## Proposal for the 09 series of amendments to UN Regulation No. 16

### Submitted by the experts from Japan\*

Figure 1  
Photo of the Buckle Strap Path of the UN Regulation No. 129 Test Bench

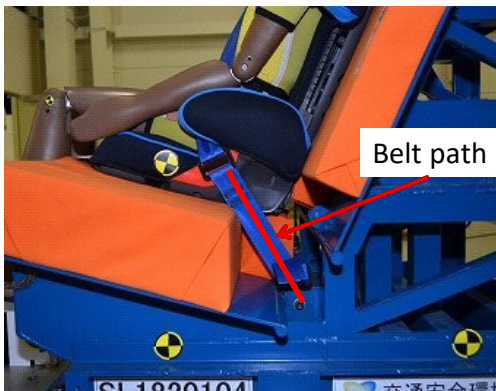
1. The strap’s paths between the effective safety-belt anchorage and the buckle are normally straight like the test bench specified in UN Regulation No. 129 (Figure 1). However, the strap’s paths between the effective belt-anchorage and the buckle of some vehicles in the market are not straight and are curved along the cushion (Figure 2).

- 8.2.3.**        **The requirement of the strap between the buckle and effective belt anchorage at seats except for the front row of vehicles of categories M1.**
- 8.2.3.1.**      **The difference between the actual strap length and the straight line distance between the EA and Bd point should be 50 mm or less**
- The above requirements may be shown by the actual vehicle, parts, drawings or 3D data at the manufacturer's choice.**

**8.2.3.2. If the difference between the actual strap length and the straight line distance between the EA and Bd point is greater than 50 mm, the requirements of paragraph 8.2.3.1. need not be satisfied as long as one of the following conditions is met. The applicant may demonstrate that the conditions are met by means of experimental data, simulation data, strength calculations, etc., subject to agreement with the Technical Service.**

Figure 2  
Photo of the Buckle Strap Path When Not Straight

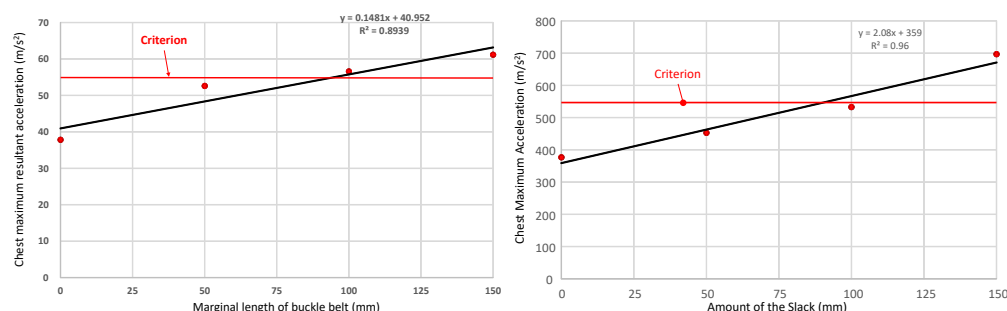
2. When the strap’s paths between the effective belt anchorage and the buckle are not straight, the occupants may move significantly forward during a frontal impact accident. If an occupant is seated in the booster seat attached by ISOFIX, there are cases in which the seatbelt slips up to the neck and in which submarining occurs (referred to in GRSP-69-24). These phenomena would increase the risk of injuries to the neck and abdomen of a child occupant. In addition, the dummy chest injury increases. Figure 3 shows the relation between the amount of slack of the buckle strap and dummy 3 ms chest maximum acceleration for two types of CRS. When the slack of the buckle belt was over [50] mm, the chest maximum acceleration approached UN Regulation No. 129 criteria in one CRS. When the slack of the buckle belt was over [80] mm, the chest maximum acceleration exceeded the above-mentioned criteria.
